Project: Kingscliff High School		Contractor: RCC	
Date of Inspection: 18/10/2023		Start Time:	
Inspection by: Nerisa Balliu		Finish Time:	
Project No: BR210028		Weather:	
Inspection Report No: CM-1	No. Pages:	Site Engineer's Name:	
Works Inspected: Building C Middle Ground Floor Steelwork			
Drawings Reference: KHS-S-C-03.01, KHS-S-X-00.27, Site advice: 230612_BLDG C Middle_Additional STR Input

RE: KINGSCLIFF HIGH SCHOOL STAGE 2 MAIN WORKS – AS-CONSTRUCTED BRACE WALL

Re: Kingscliff High School, Kingscliff NSW
OC Structural Certification – Building C Middle

SITE INSPECTION REPORT

Figure 1 - Original Brace Wall taken from KHS-S-C-04.00 Issue 2

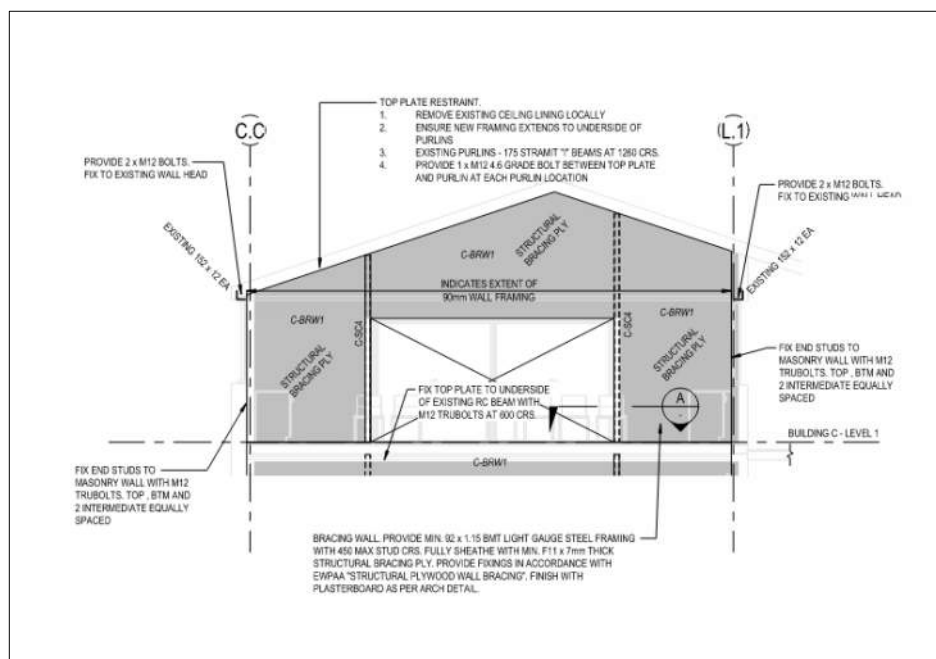
We also understand that the penetration as shown on the original documentation (KHS-S-C-04.00 Issue 2) was not required and that the bracing wall extends for the full length without any voids.

We certify that the lateral bracing capacity of the as-construction wall exceeds the capacity of the C-BRW1 wall (with the internal void) shown on Acor Consultants structural engineering sheet KHS-S-C-04.00 Issue 2 (refer snippet below)

PLYWOOD BRACING PANEL ELEVATION
(6.4kN/m CAPACITY METHOD A, AS1684)
 NTS

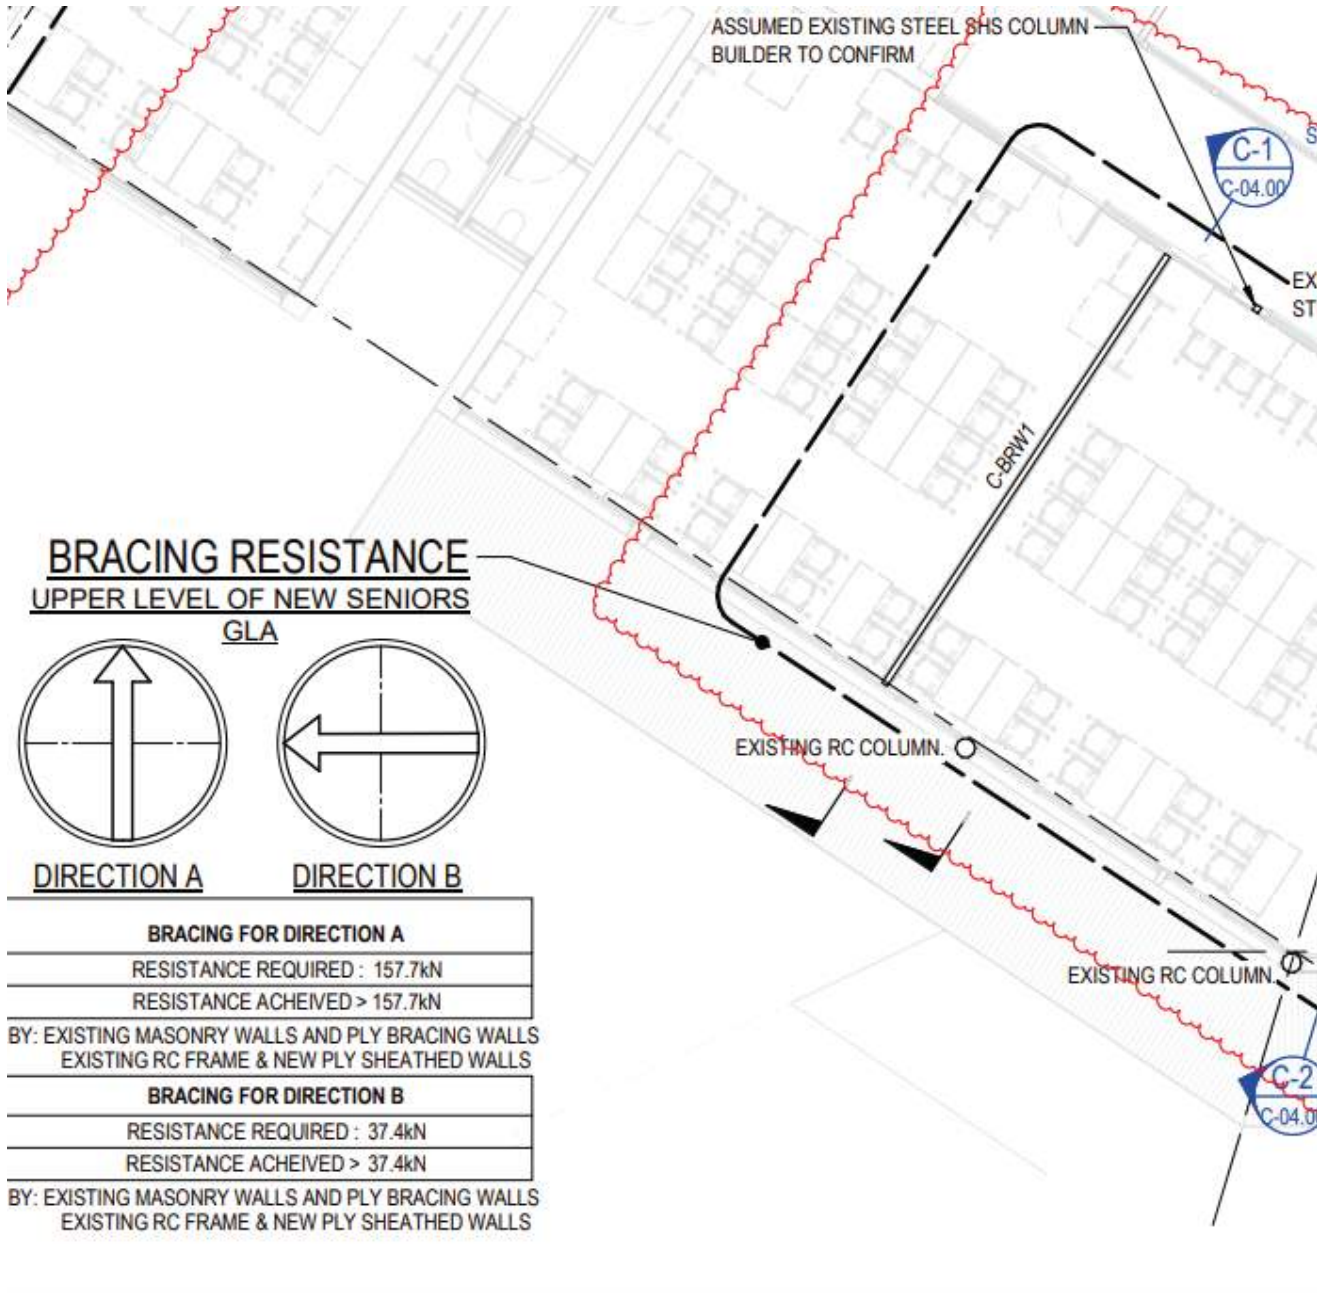
The Engineer has queried the Ply Bracing wall currently installed not being as per their detail (below). Can you confirm the loads mentioned (below) can still be achieved based on the installation method?

Can you please advise why ply bracing has not been installed as per our drawings?

When we constructed the wall we hadn't received the drawing that informed us that it was a bracing wall. Once we received this information we then installed more fixings to the floor and fixed the top plate off to the ceiling purlins more often. Due to the fact you hadn't installed any structural steel posts in the wall we increased the thickness of the structural ply and fixed it off at closer spacings. We also fixed the impact board off at closer fixings. In my opinion the wall is As structural or more than it would have been.
